**Re:** *Addendum No. 4*  
*Nason Basin to Grove Avenue Storm Sewer Phase 1*  
*City of Willoughby*

Date: March 11, 2025

FIG 2.19.1

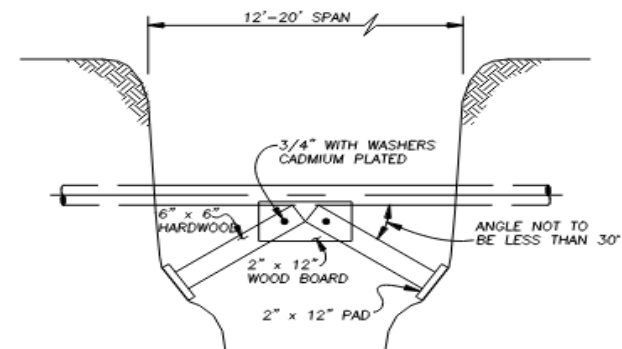
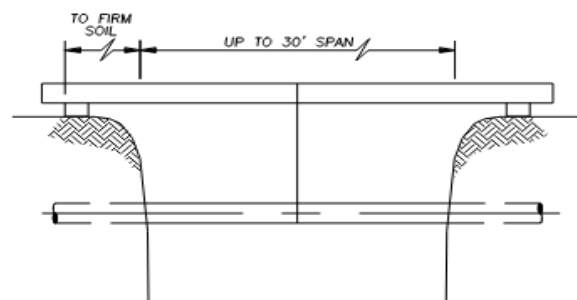
**ADD** attached detail FIG. 2.19.1 to plan sheet 32/43.
